TRAILS AT ASPEN RIDGE

FILING NO.4
GRADING & EROSION CONTROL PLANS

TRAILS AT ASPEN RIDGE			
FILING NO.4 GRADING & EROSION CONTROL PLANS			
GRADING & EROSION CONTROL PLAN			
DESIGNED BY:	BAS	SCALE	DATE ISSUED:
CHECKED BY:	NMS	HORIZ. 1" = 50' VERT. N/A	JUNE 2021
SHEET			4 OF 8
DRAWING No.			GEC01

CROSS SECTION A-A PROFILE
SCALE: (H) 1" = 50' (V) 1" = 10'

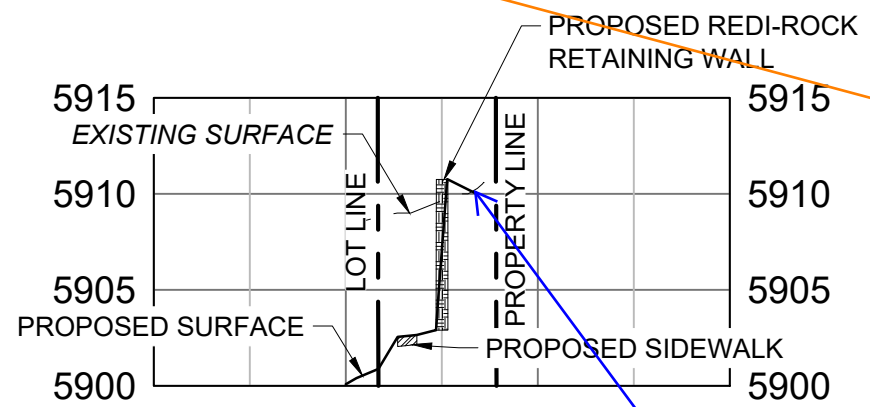
Update contours and clearly label the proposed swale being constructed at the top of wall. Identify the swale side slope and identify the minimum and/or maximum required depth of swale

VTC-1. AGGREGATE VEHICLE TRACKING CONTROL

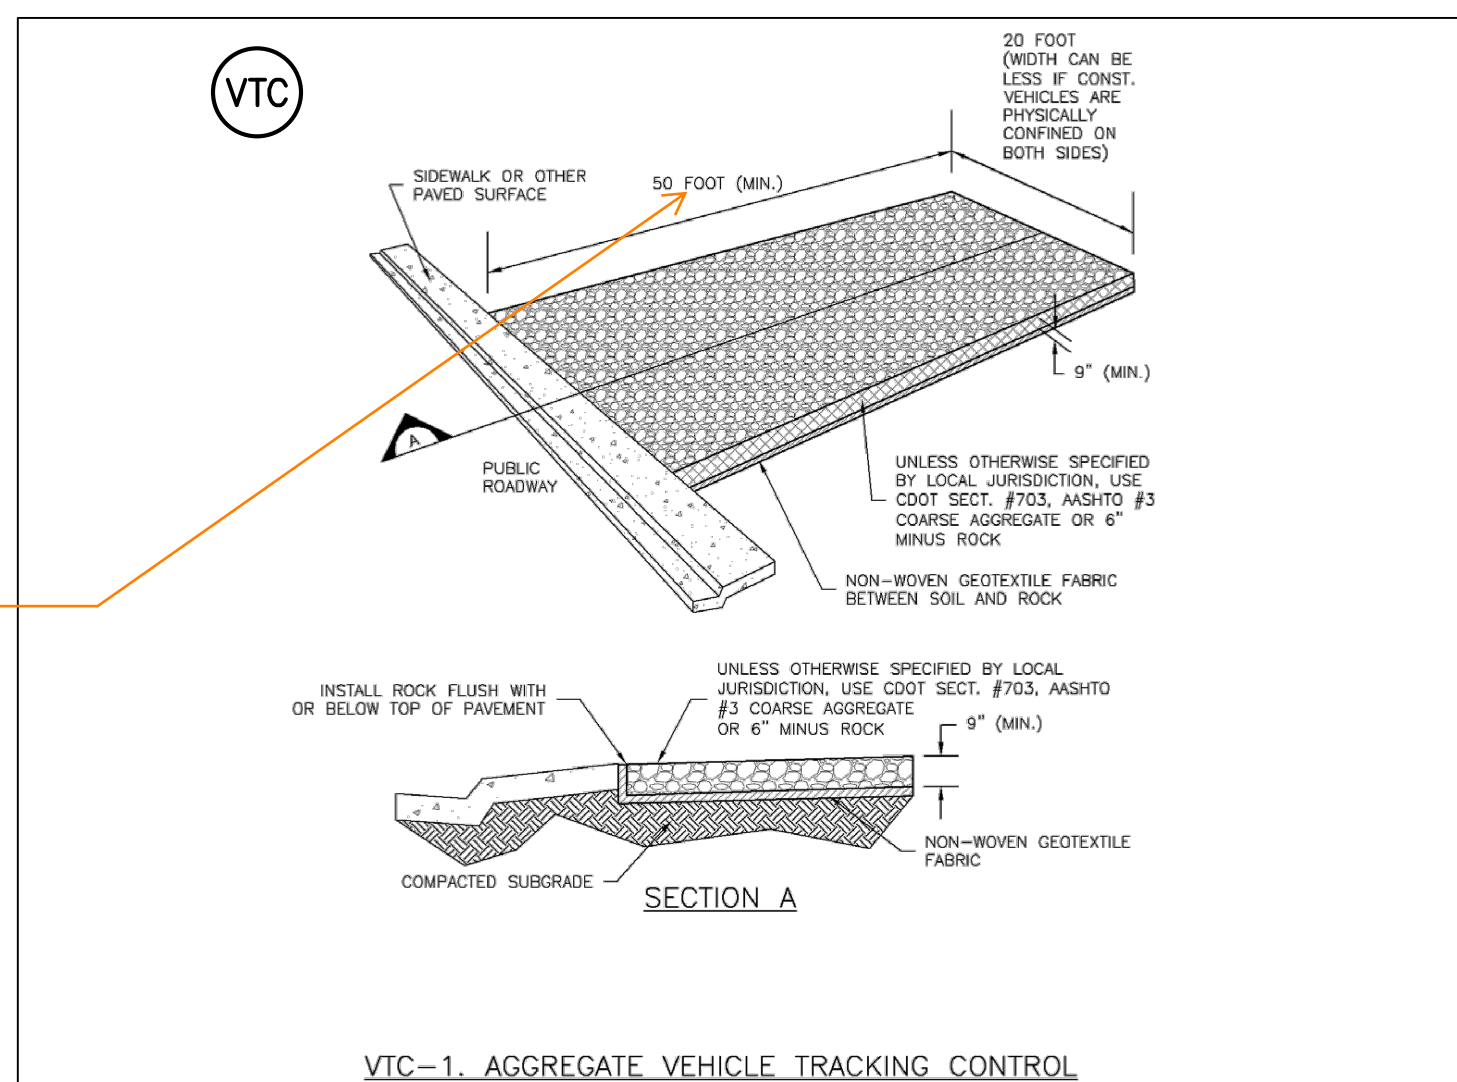
replace with EPC approved VTC detail (VT-1 and VT-2 in DCM Vol. 2, Chap 3.3) or revise to be 75ft min length

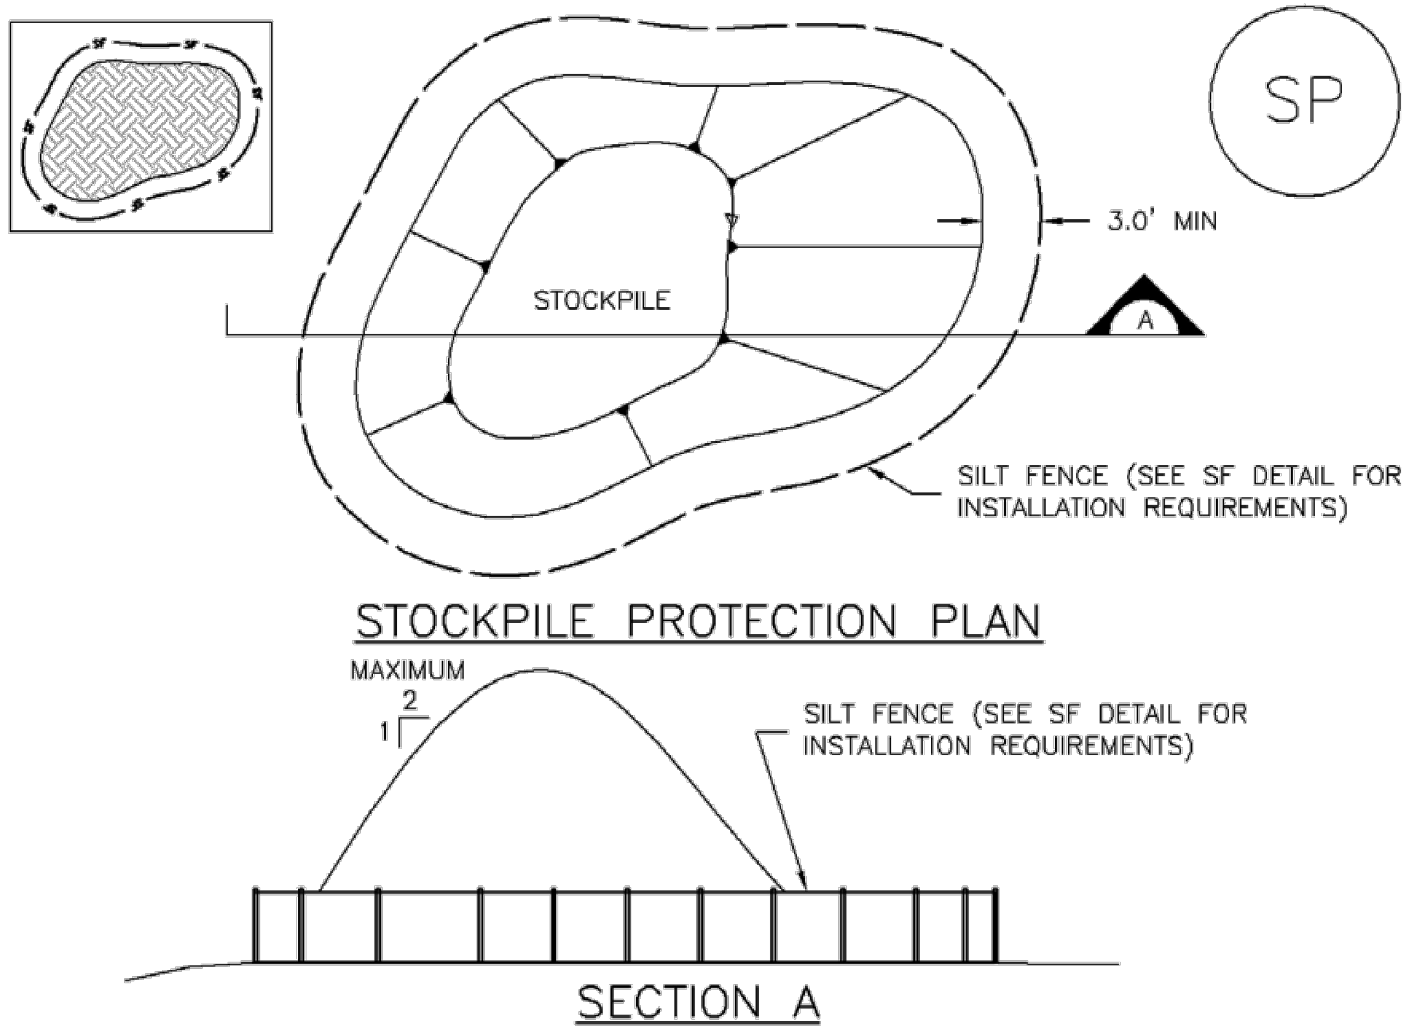
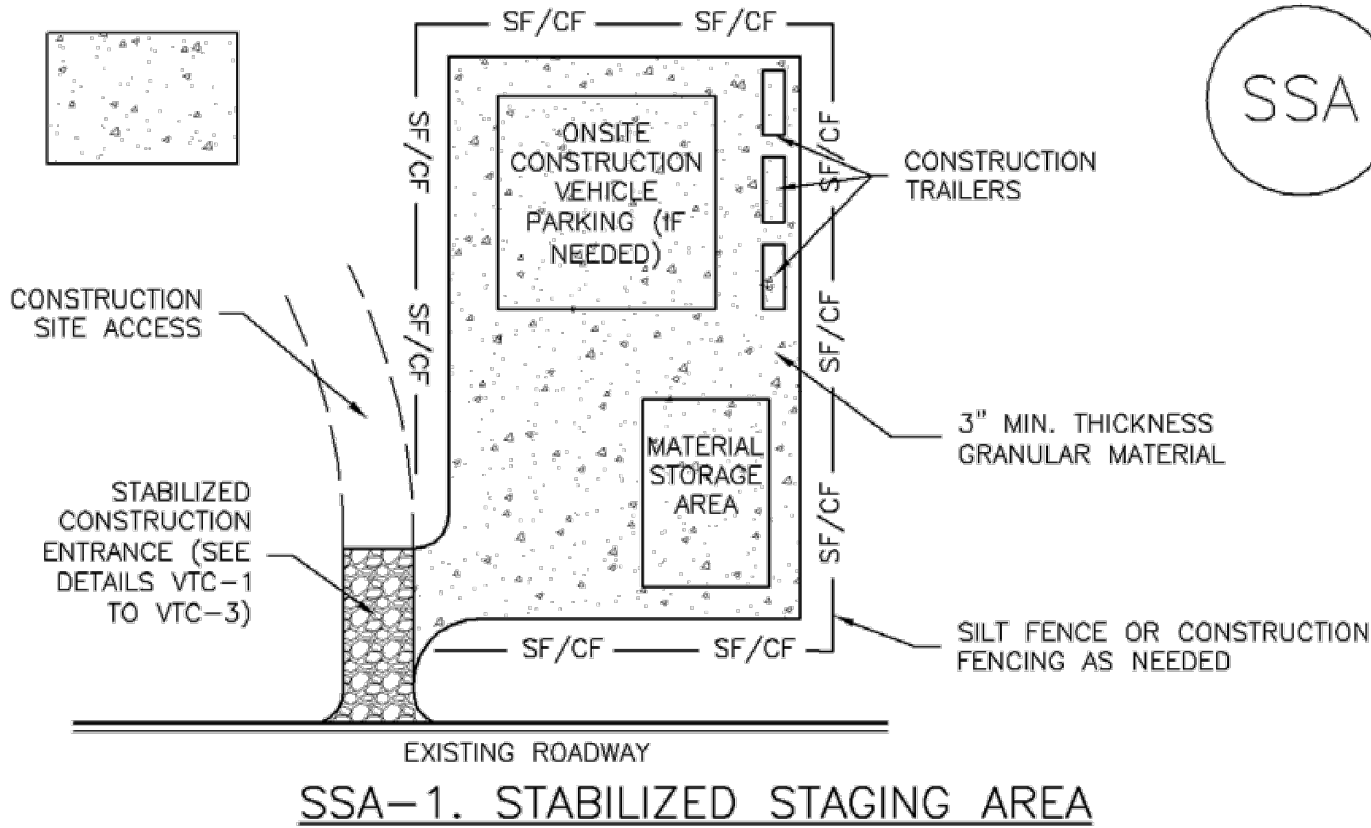
Include details for the following BMP's. Examples of acceptable details for each are provided:

BMP	Detail # and Source			
	DCM (Vol 2: Chap 3.3)	MHFD (USDCM Vol 3: Chap 7)	CoS - Stormwater Construction Manual	
Mulching	MU-1	EC-4	X

Per my comments on the Sheets above, if Rough Cut Street Control, Check Dams, and/or Straw Bales are added to the GEC Plan, add details for them to this sheet.
